PIC32MZ EF FAMILY

PIC32MZ Embedded Connectivity with Floating Point Unit (EF) Family Silicon Errata and Data Sheet Clarification

The PIC32MZ Embedded Connectivity with Floating Point Unit (EF) family of devices that you have received conform functionally to the current Device Data Sheet (DS60001320G), except for the anomalies described in this document.

FIGURE 1: Posc CRYSTAL CIRCUIT

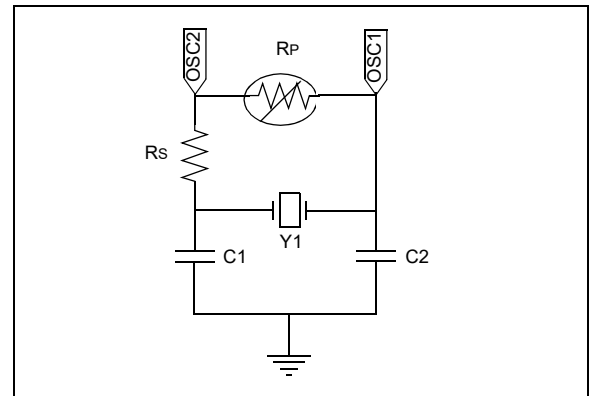
Revision A1 Silicon: A crystal oscillator cannot be used as an input to the Primary Oscillator (Posc) pins OSC1 and OSC2.

Revision A3 and B2 Silicon: The Posc has been tested in a normal power-up sequence and supports specific crystal operation.

The Primary Oscillator (Posc) has been characterized to operate at 8 MHz, 12 MHz, and 24 MHz when the circuit in [Figure 1](#) is implemented, and the operating conditions listed in [Table 3](#) are met.

Crystal Frequency (see Note 1)	Series Resistor (Rs)	Posc Gain Setting POSCGAIN<1:0> (DEVCFG0<20:19>)	Posc Boost Setting POSCBOOST (DEVCFG0<21>)
8 MHz	2 kΩ	'0b00 (GAIN_0)	'0b1 (ON)
12 MHz	1 kΩ	'0b00 (GAIN_0)	'0b1 (ON)
24 MHz	0 kΩ	'0b00 (GAIN_0)	'0b1 (ON)

- Note 1:** Using any other crystal frequency will require special component selection and characterization.
- Note 2:** A parallel resistor (Rp) should not be used to increase the gain of the POSC.
